Government of India-Ministry of Railways
Research Designs & Standards Organisation

MODIFICATION SHEET No. RDSO/2016/EL/MS/0452 Rev.'0' dtd-29. 04.2016

To overcome the failure of K-8 contactor of Battery Charger of M/s. Siemens make 180 KVA Static Converter.

Fig 1: Location of K -8 contactor (to be removed) in 180 KVA Static converter of Siemens make.

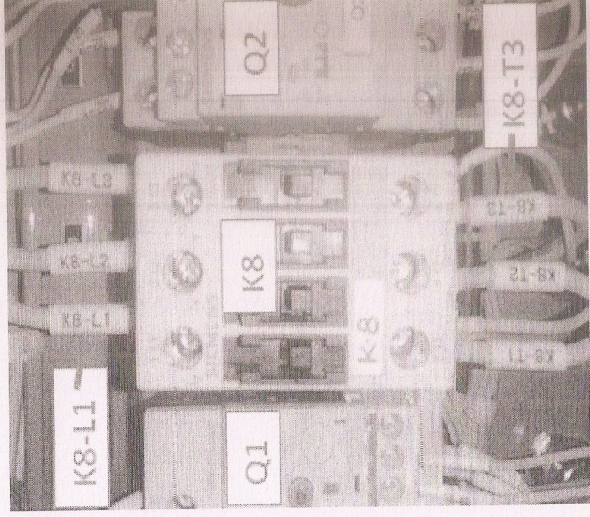
There had been frequent failures of K-8 contactor in Battery Charger of 180 KVA Static Converter of M/s.Siemens make. The K-8 contactor is being used in reverse polarity protection of Battery Charger. It was noted that sometimes on line the K-8 contactor is not getting closed either due to mechanical jamming or sometimes coil of the contactor getting stuck due to misbehavior of interlocks. The non closing of contactor drains the battery leading to line failure of locomotive and subsequent blocking of section. In this regards a meeting was conducted with M/s. Siemens regarding K-8 contactor failure with the representative of M/Siemens on

- (i) The K-8 contactor is mounted at the top in between the Q1 & Q2 MCB at the Electronic compartment where M 1300 card is mounted.

The K-8 contactor is used for reverse polarity protection of the out put of Battery Charger. The main purpose of contactor is to protect reverse polarity protection and comes in picture at the time of either commissioning or at the time of removing / re connecting the output wires of the charger. If it is isolate/short there will be no effect of the performance and operation of Static Converter.

4.1. To ~~by~~ pass the contactor the wire **K8 L-1** wire from the interlock L-1 is to be removed and connect with the wire **K 8 T-3** in the same terminal of T 3 interlock. The wires are to be shorted. (Fig -1 may be referred for placement of **K8 L-1** and **K8 T-3**).

- 5.1** The wire no **K8 L-1** wire is to be removed from the interlock L-1 and to be connected with the wire **K8 T-3** in the same terminal of T 3 interlock.
- 5.2** The micro fuse (glass fuse) from fuse holder **F7A & F14A** which are mounted at left panel wall below U 4 sensor are also to be removed, so that 110 volt supply cannot energize the coil.

Fig 2: Location of micro fuses (to be removed). 180 KVA Static Converter of Siemens make.

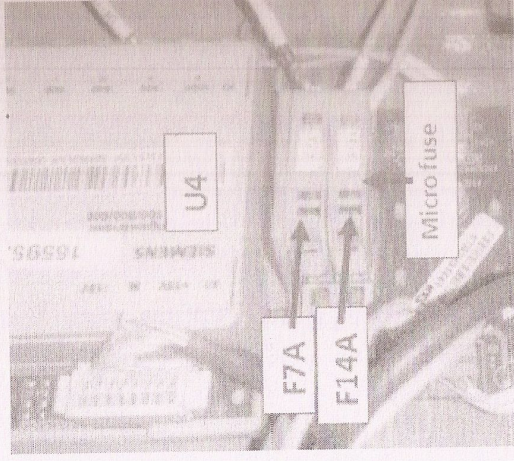
4.2. The micro fuse (glass fuse) from fuse holder **F 7A & F14A** which are mounted at left panel wall below U 4 sensor also to be removed. This is to be done on safety measure as by removing the micro fuse 110 V supply will not energized the Coli. The location of micro fuse is below U 4 sensor .
